Novi Ten Townhomes JSP14-18 with Rezoning 18.707

Public hearing of the request of Toll Brothers for Planning Commission’s recommendation to City Council for rezoning of property in Section 26, on the south side of Novi Road, east of Ten Mile Road from I-1, Light Industrial and OS-1, Office Service to RM-1, Low Density, Low-Rise Multiple-Family Residential with a Planned Rezoning Overlay. The subject property is approximately 20.9 acres.

Rezoning request from I-1 Light Industrial and OS-1, Office Service to RM-1 Low-Density Multiple-Family with Planned Rezoning Overlay (PRO) – Revised Concept Plan

Novi Ten Townhomes PRO JSP14-18
 Revised Concept Plan/Rezoning Review
 Plan Date: 8/18/14

Figure 2. Wetland Delineation Map (Provided by King & MacGregor Environmental, Inc.)

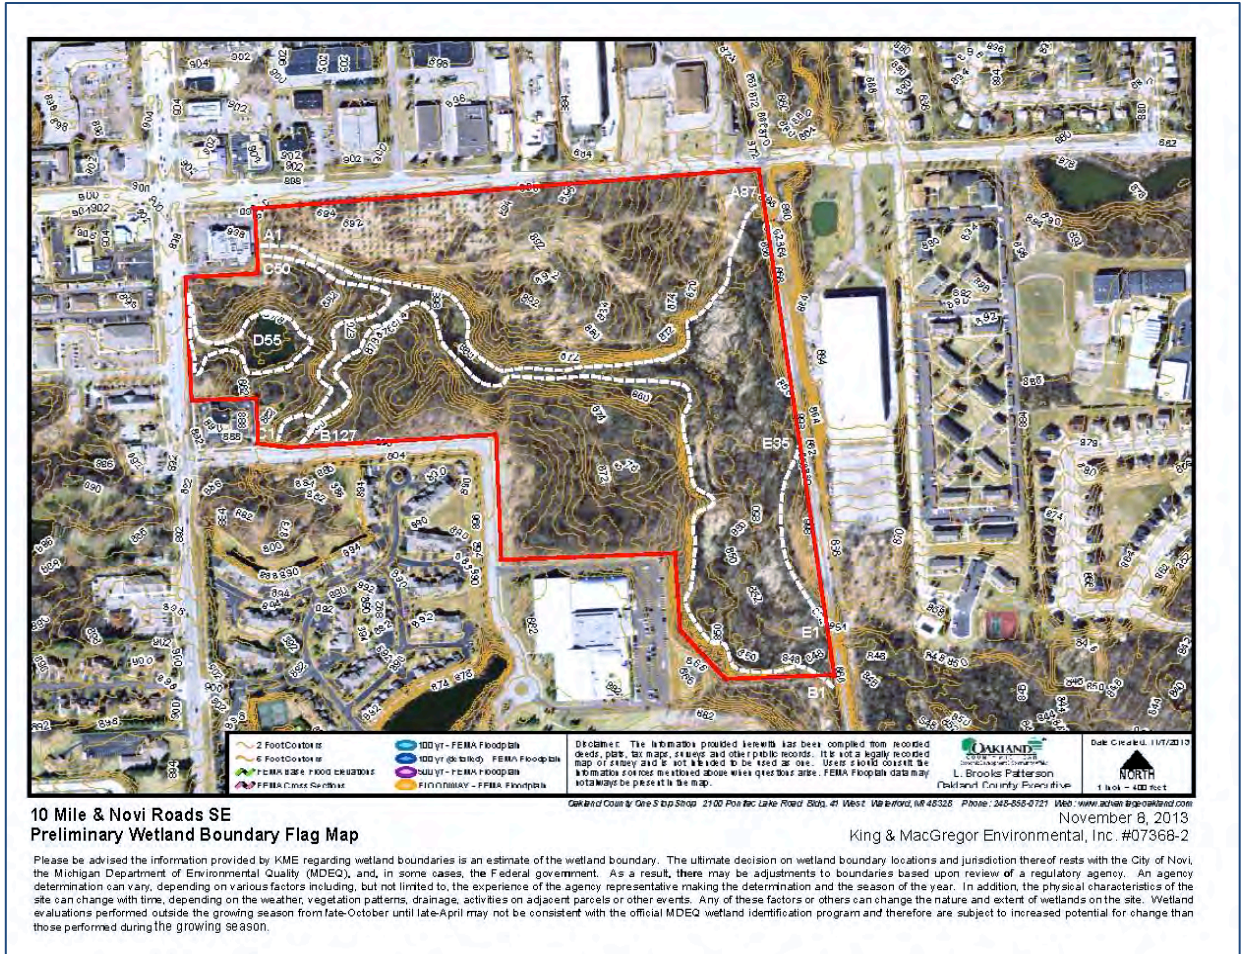
The *Planned Rezoning Overlay Plan* (Sheet 2) indicates areas of wetland surrounding the proposed development site. As noted, these wetland areas were delineated by King & MacGregor Environmental, Inc.

Currently, the Plan does not indicate proposed, direct impact to wetlands. However the Planned Rezoning Overlay (PRO) Plan (Sheet 2) does indicate a proposed 8’ wide pedestrian boardwalk/bridge. The impacts associated with this work do not appear to be indicated or quantified on the Plan. Subsequent site plans should include a detailed description of both permanent and temporary wetland and wetland buffer impacts associated with this proposed boardwalk/bridge.

While the Plan includes proposed impacts to on-site wetland buffer, the Applicant has made an attempt to minimize proposed wetland disturbance. The following table summarizes the existing wetlands and the proposed wetland impacts as listed on the *Planned Rezoning Overlay Plan* (Sheet 2):

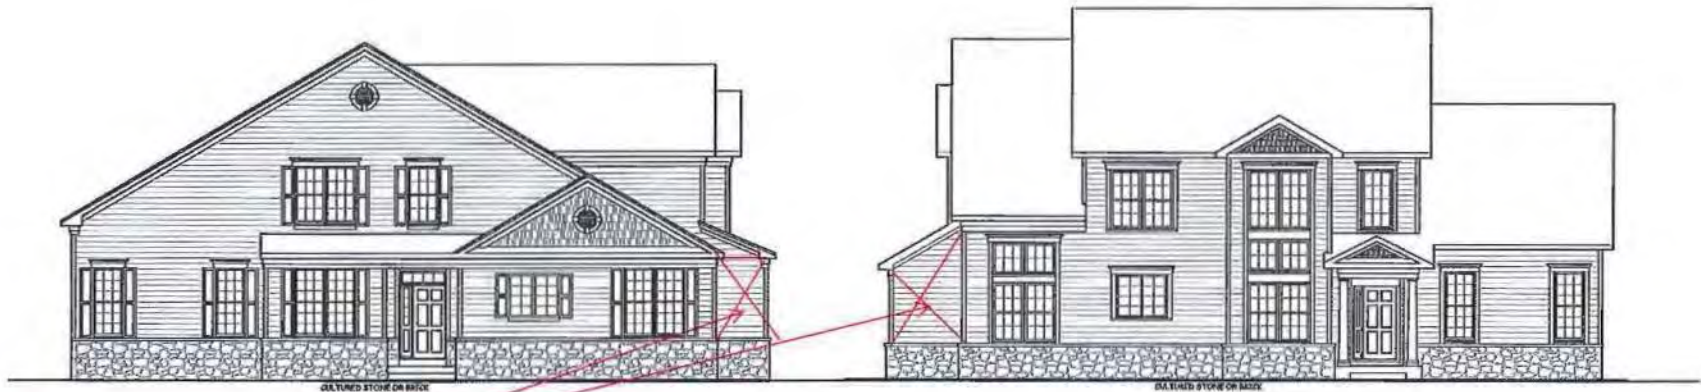
The PRO Ordinance requires that the *proposed land development project result in an enhancement of the project area as compared to the existing zoning, and such enhancement would be unlikely to be achieved or would not be assured in the absence of the use of a Planned Rezoning Overlay.* We believe that the requirements of Section 2520, The Façade Ordinance with respect to the types and percentages of materials must be met or exceeded to achieve compliance with this Section.

Recommendation: It is our recommendation that the revised facades meet the intent and purpose of the Façade Ordinance and that a Section 9 waiver be granted for the underage of brick and overage of siding and asphalt shingles. Likewise, the revised facades are consistent with the intent and purpose of Ordinance Section 3402.
